Smart Key Intermittent No Crank/No Start

Service Category Vehicle Interior

Section Theft Deterrent/Keyless Entry

Some customers may experience a no crank condition or a start and immediate stall condition when starting the engine using the “Push Start” switch. A new “Push Start” switch is now available to address this concern.

Figure 1.

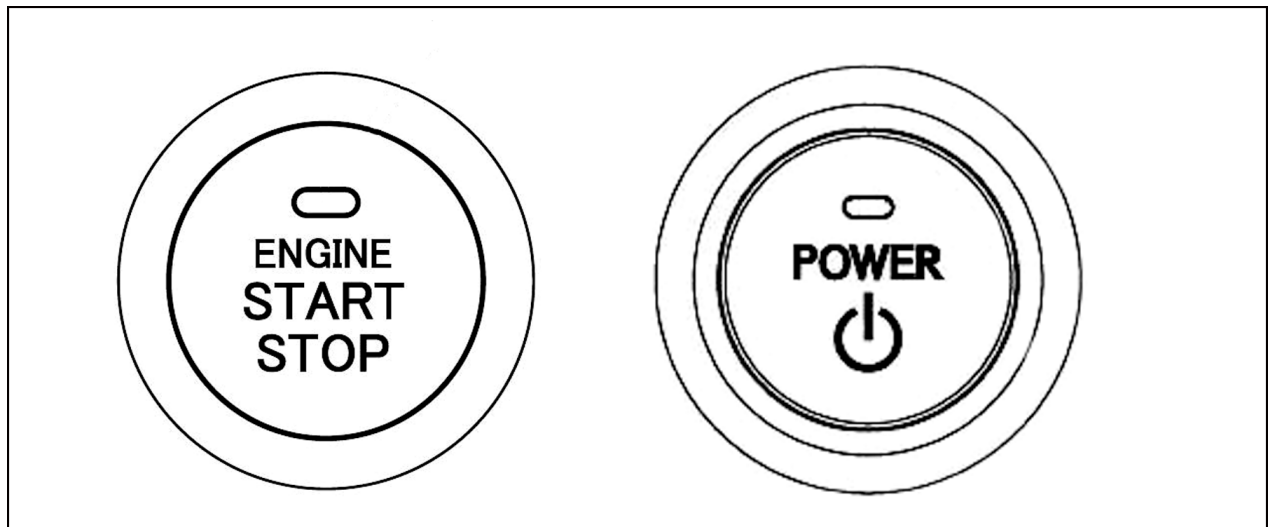
This TSB details the replacement of the push start switch on vehicles equipped with Smart Key with one of two specific concerns, both of which are intermittent issues that can occur only while starting the engine.

- No crank and no start concern.
- Engine cranks, starts and then immediately stalls.

MODEL(S)	PREVIOUS PART NUMBER	CURRENT PART NUMBER	PART NAME	QTY
LS600h	89611-50020	Same	Switch, Push Start	1
LS460/460L	89611-50010	89611-50011		1
GS450h	89611-30030	Same		1
ES 350, GS350, IS250/350	89611-30020			1
